# Parkview Dresses Ltd. (9902)

19.AUGUST.2014

# Identified Priority 3 Concerns

Beam and slab of existing site

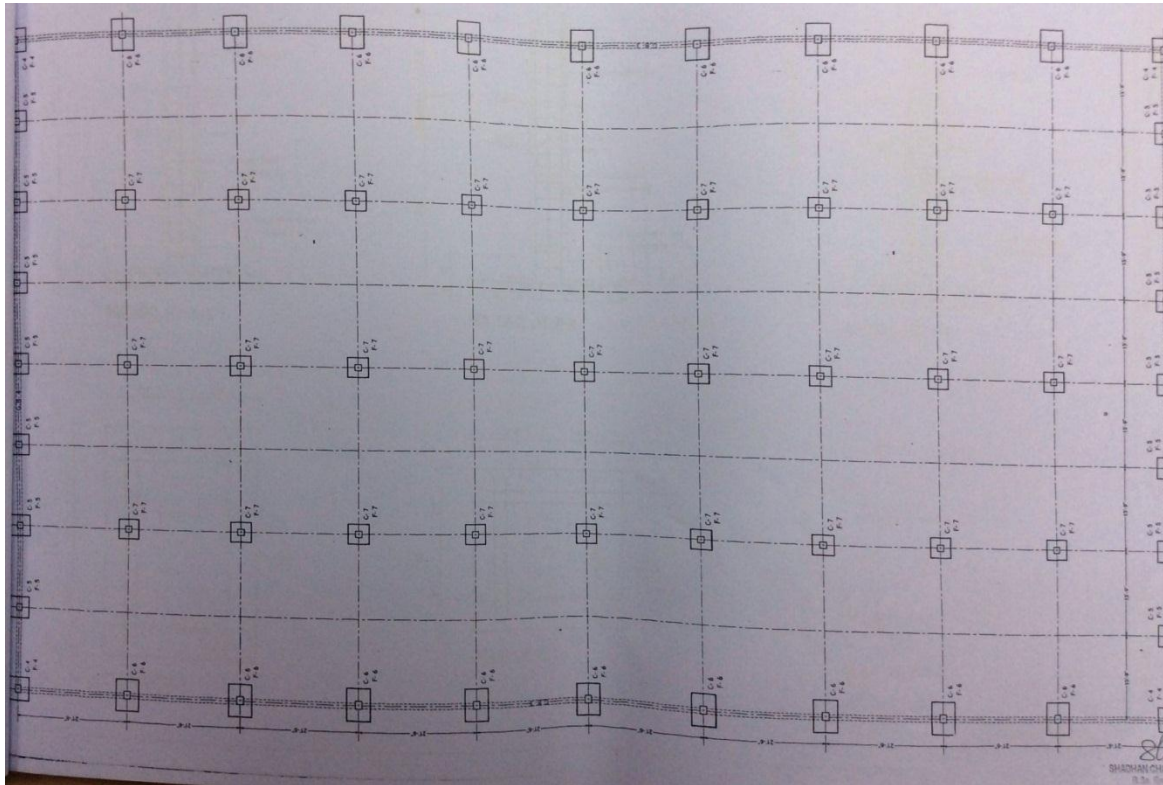
There is no structural drawing showing the typical framing layout.

The foundations on the structural drawing are very small and appear inadequate.

The As-built drawings need to be updated and supplemented where necessary to more accurately reflect the actual existing construction.

The factory's Structural Engineer needs to investigate this in more detail and should determine exactly the dimension of the foundations and therefore their adequacy as soon as possible.
